[MPC Comment] Question for MPC - Campbell Station Road: 5-B-17-SP

[MPC Comment] MPC File 5-B-17-RZ

[MPC Comment] Comments regarding 5-B-17-RZ and 5-B-17-SP

In regards to 5-B-17-RZ and 5-B-17-SP.

Figure 1. View heading north on N. Campbell Station Rd. looking up the property. Notice how of the terrain flows and that there is no stream at the low point of the unwooded land. This is because the stream starts at the spring in the woods just south (right-hand side of picture) of the field.

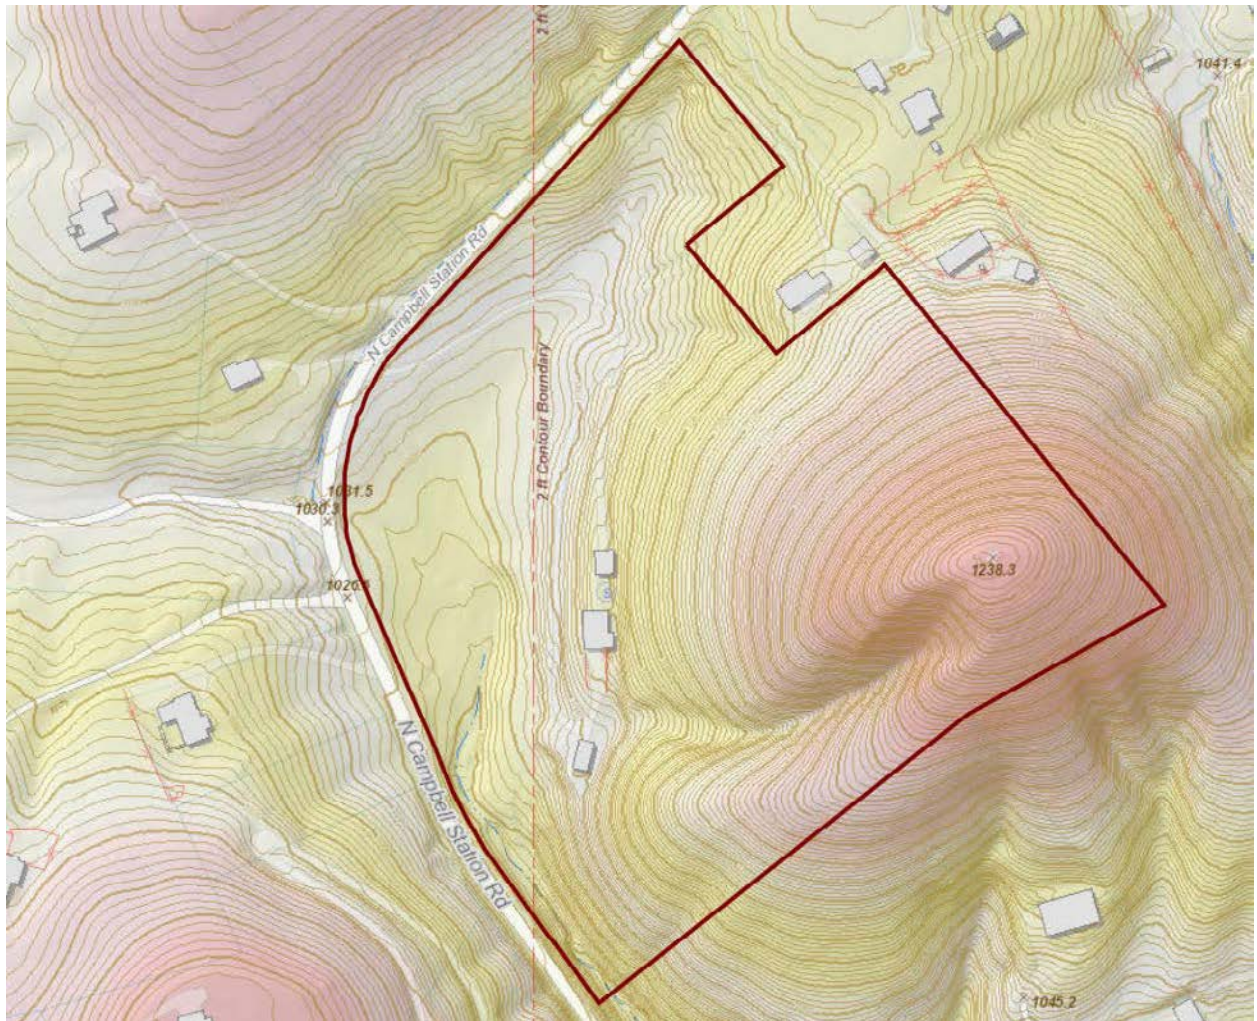
I am concerned about several aspects of the proposed development that will result from this rezoning. Foremost, there is a spring located on the property that has such high volume of output that is the source of the unnamed creek that keeps the ponds downstream filled and flows all the way to Hickory creek. It is also the drainage for the entire area of north Campbell station from Montsview Drive to Hickory Creek. The entire lot is a wide drainage that is roughly 20 feet below the level of Campbell Station Rd, Figure 1.

To make any flat spots for even just a foundation will require extensive cut and fill. Even with a large culvert buried across the entire property and destroying the spring it is only a matter of time before it results in a major flood problem. Especially, since the only person with knowledge of what is buried will be the developer and once they leave there will be no one with any responsibility or knowledge of the critical situation should any culverts or other drainage systems become clogged. It is a terrible lot for development. Too steep, too critical to the safe drainage of the entire area south crest of the ridge to the north of the lot and everything south from there to Hickory Creek, Figure 2. What are they going to do fit homes on to such steep slopes? Strip mining the hill and filling the drainage? Bury the spring supplying water to everyone downstream. It is the source of the unnamed creek that parallels N. Campbell Station Rd beginning on this lot until it joins Hickory Creek to the south.

Figure 3. Hillside slope map from KGIS

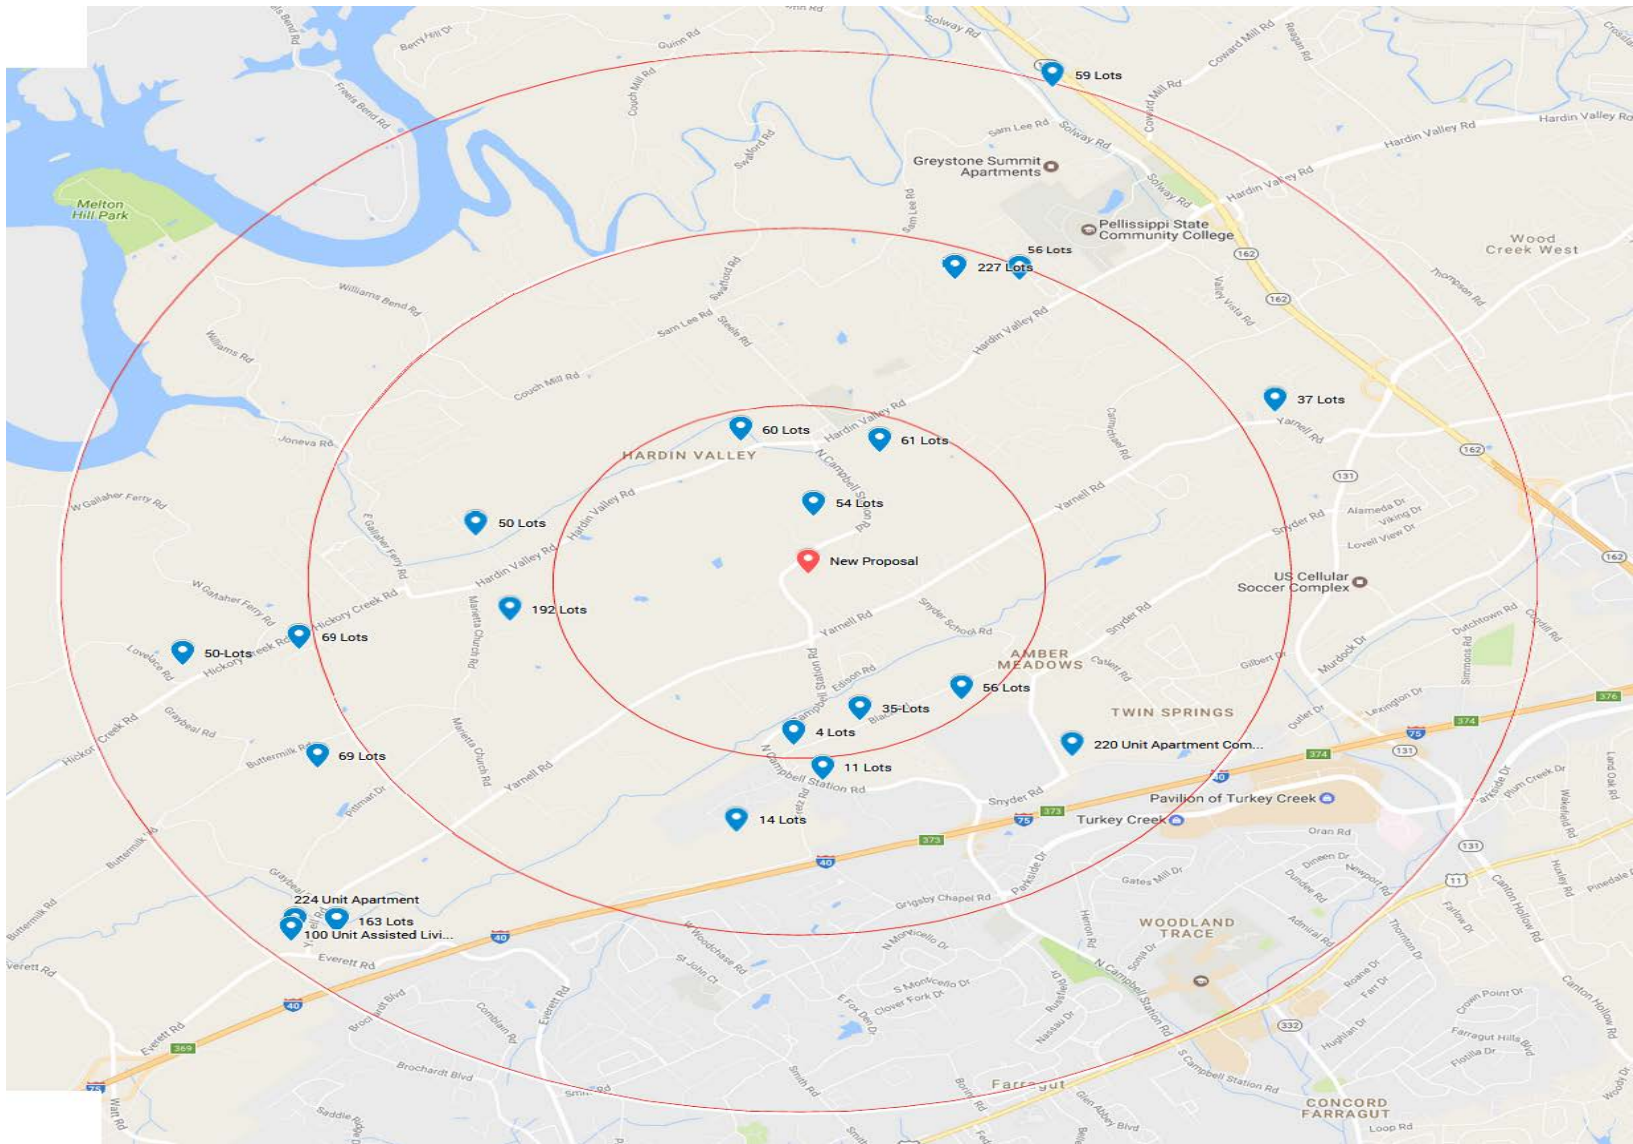
This all exceedingly clear by the fact that over 50% of the land has a slope of over 25%, Figure 3!
